STATESVILLE MAIN LIBRARY MECHANICAL MODIFICATIONS MANDATORY PRE-BID MEETING MINUTES & ADDENDUM #1 APRIL 29, 2021 AT 9:00AM

DRAWING TITLE:
MECHANICAL DRAWING ME1.2, ADD FENCE
1/8"=1'-0"

PROJECT:
PUBLIC LIBRARY MECHANICAL MODIFICATIONS
STATESVILLE, IREDELL COUNTY

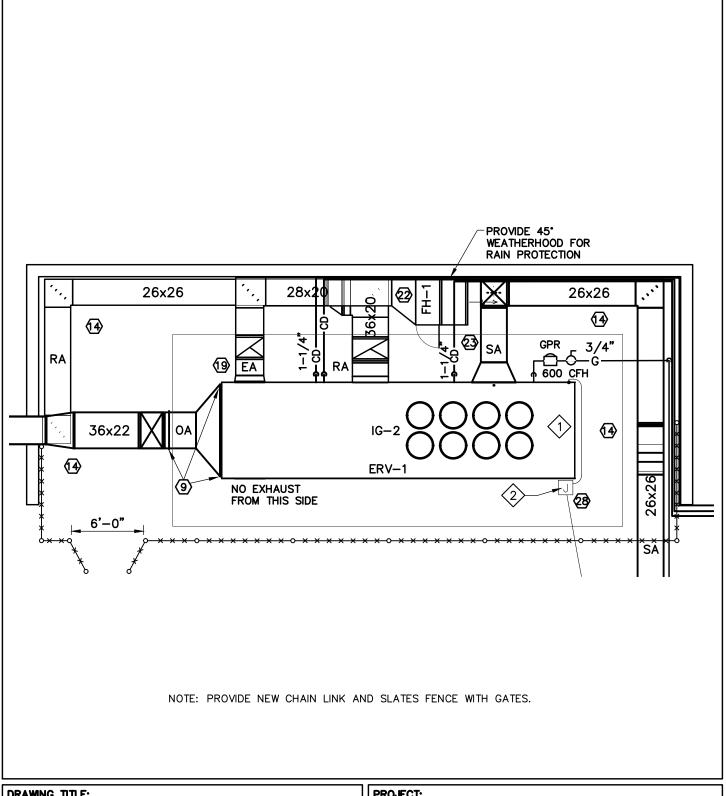
1) Provide new chain link and slates fence with gates as shown on attached bulletin drawing. Poles with concrete foundation at the corners and every 8 ft max. Chain link fences shall be 8 feet high 9 gauge, 2" mesh, galvanized steel fabric fabricated in one piece widths, with colored slates (match green color of chiller fence). Gates, and pull posts shall be 2-3/8" od galvanized steel pipe. Line posts

shall be 2-3/8" od galvanized steel pipe. Line posts shall be spaced at not more than 8'-0" o.c. top and bottom rails pipe sections shall be not less than about 18' long (field verify) and shall be fitted with couplings for connected lengths into a continuous run. Couplings shall be not less than 6' long with a .070" wall thickness and shall allow for expansion and contraction of the top rail. The top rail shall pass thru the line posts. The rail shall be securely connected to end and corner posts with galvanized steel connectors. Gates shall have a frame fabricated from 1-7/8" od galvanized steel pipe. With either welded joints or securely connected with galvanized steel connectors. The complete installation shall be in accordance with the fence systems manufactures written instructions.

Fence posts shall be set in min 16" concrete below grade, or as per fence

Fence posts shall be set in min 16" concrete below grade, or as per fence manufacturer's directions, prior to forming and pouring pad. All concrete shall be 3,000 psi at 28 days.
